Form 3160-5
(June 2019)UNITED STATES
DEPARTMENT OF THE INTERIOR
BUREAU OF LAND MANAGEMENTFORM APPROVED
OMB No. 1004-0137
Expires: October 31, 2021**SUNDRY NOTICES AND REPORTS ON WELLS**
Do not use this form for proposals to drill or to re-enter an abandoned well. Use Form 3160-3 (APD) for such proposals.

8. Well Name and No. ROSS DRAW 17 FED COM/702H

EOG respectfully requests an amendment to our approved APD for this well to reflect the following changes:

Revised Permit Information 06/08/2022:

Revised Wellbore

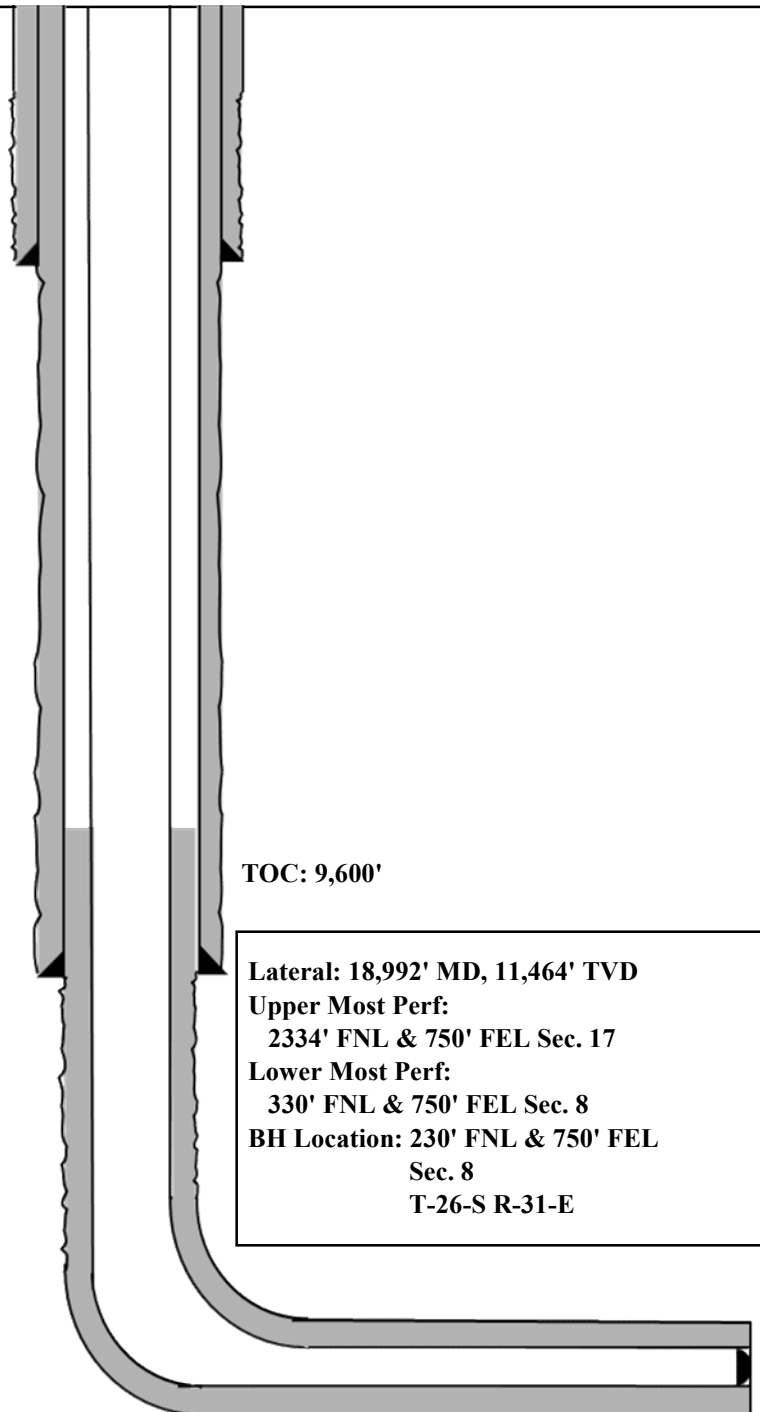
Update casing and cement program to current design.

Casing Design A

Variance is requested to waive the centralizer requirements for the 7-5/8" casing in the 8-3/4" hole size. An expansion additive will be utilized, in the cement slurry, for the entire length of the 8-3/4 hole interval to maximize cement bond and zonal isolation.

Variance is also requested to waive any centralizer requirements for the 5-1/2" casing in the 6-3/4" hole size. An expansion additive will be utilized, in the cement slurry, for the entire length of the 6-3/4" hole interval to maximize cement bond and zonal isolation.

Variance is also requested to waive the annular clearance requirements for the 5-1/2" casing by 7-5/8" casing annulus to the proposed top of cement.

Bit Size: 12-1/4"
9-5/8", 36#, J-55, LTC,
@ 0' - 1,310'

Bit Size: 8-3/4"
7-5/8", 29.7#, HCP-110, FXL,
@ 0' - 10,100'

Bit Size: 6-3/4"
5-1/2", 20#, P110-EC, DWC/C IS MS,
@ 0' - 9,600'

5-1/2", 20#, P110-EC, Vam Sprint SF,
@ 9,600' - 10,100'

5-1/2", 20#, P110-EC, DWC/C IS MS,
@ 10,100' - 18,992'

KOP: 11,007' MD, 10,986' TVD
EOC: 11,757' MD, 11,464' TVD

TOC: 9,600'

Lateral: 18,992' MD, 11,464' TVD
Upper Most Perf:
2334' FNL & 750' FEL Sec. 17
Lower Most Perf:
330' FNL & 750' FEL Sec. 8
BH Location: 230' FNL & 750' FEL
Sec. 8
T-26-S R-31-E

Figure 1: Cameron TA Plug and Offline Adapter Schematic

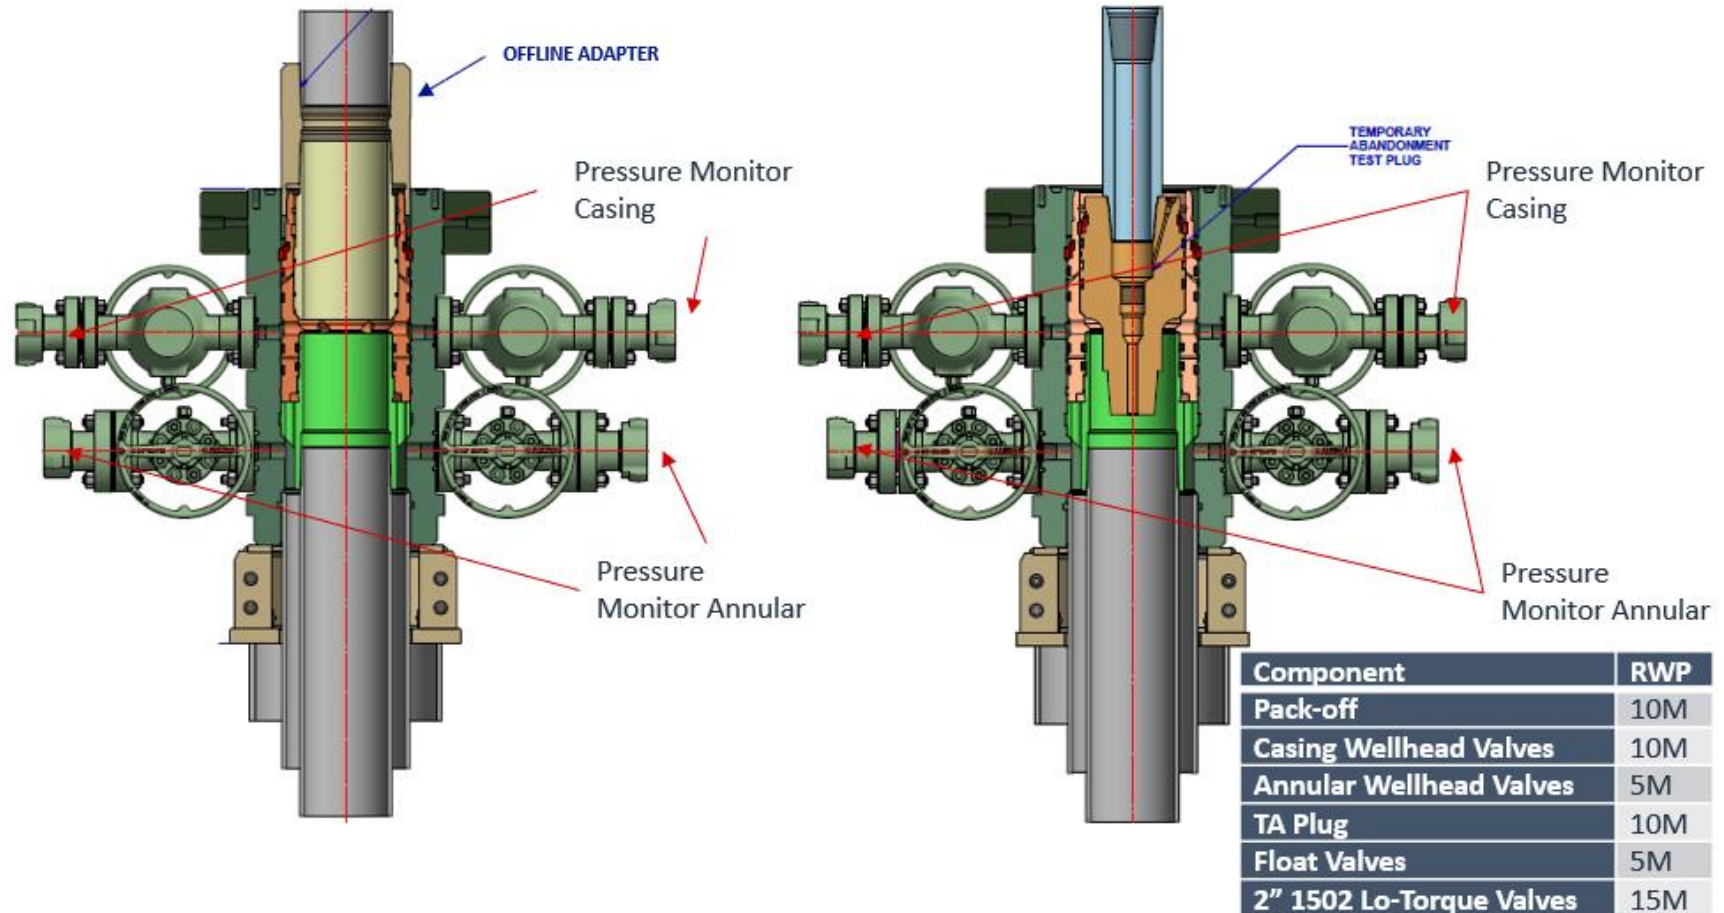
- c. Return line schematics can be seen in Figure 3.
10. Remove TA Plug from the casing.
11. Install offline cement tool.
 - a. Current offline cement tool schematics can be seen in Figure 1 (Cameron) and Figure 2 (Cactus).

Figure 3: Back Yard Rig Up

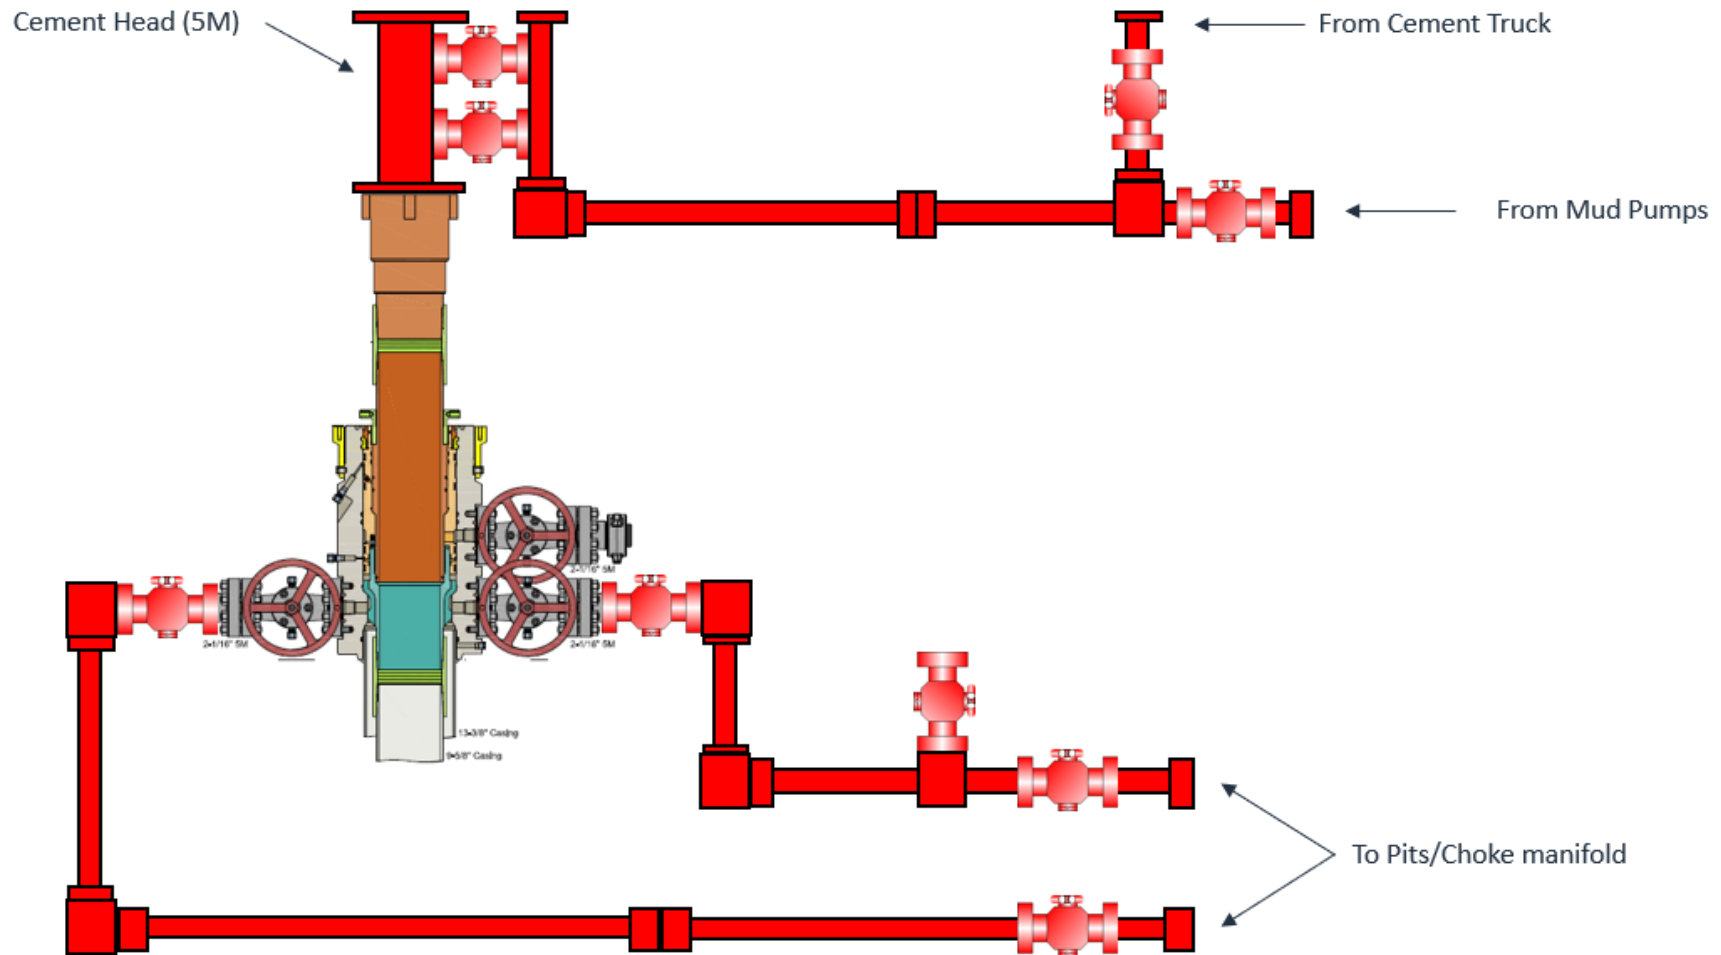
- a. Test all connections and lines from wellhead to choke manifold to 5,000 psi high for 10 min.
 - b. If either test fails, perform corrections and retest before proceeding.

Figure 4: Rig Placement Diagram

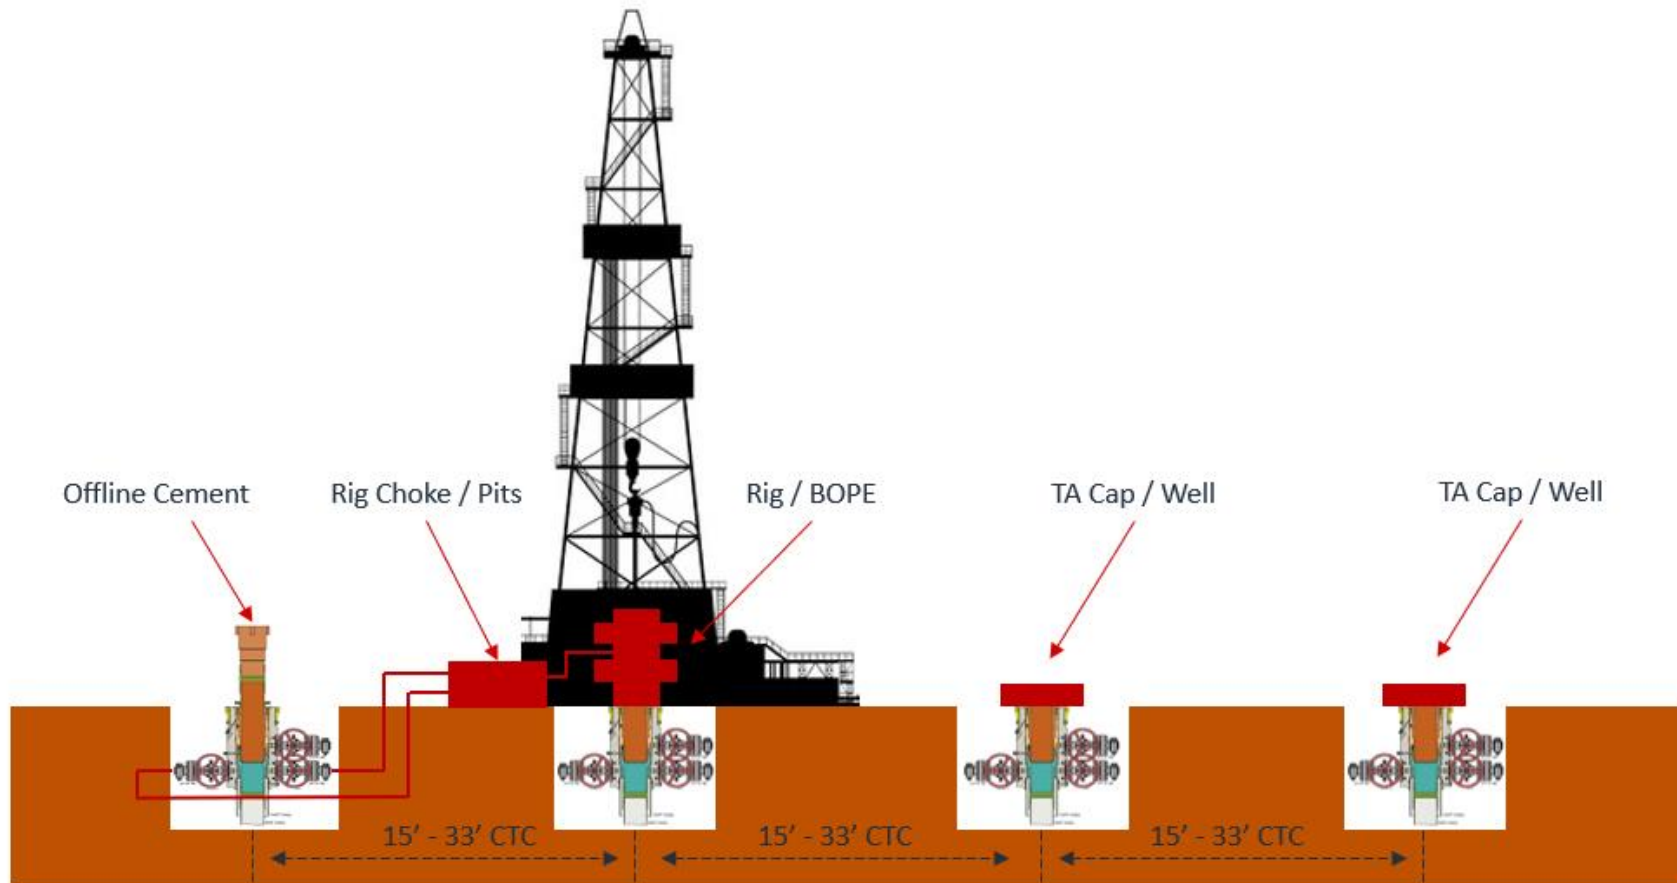
- e. Diagram for rig positioning relative to offline cementing can be seen in Figure 4.
9. Rig up return lines to take returns from wellhead to pits and rig choke.
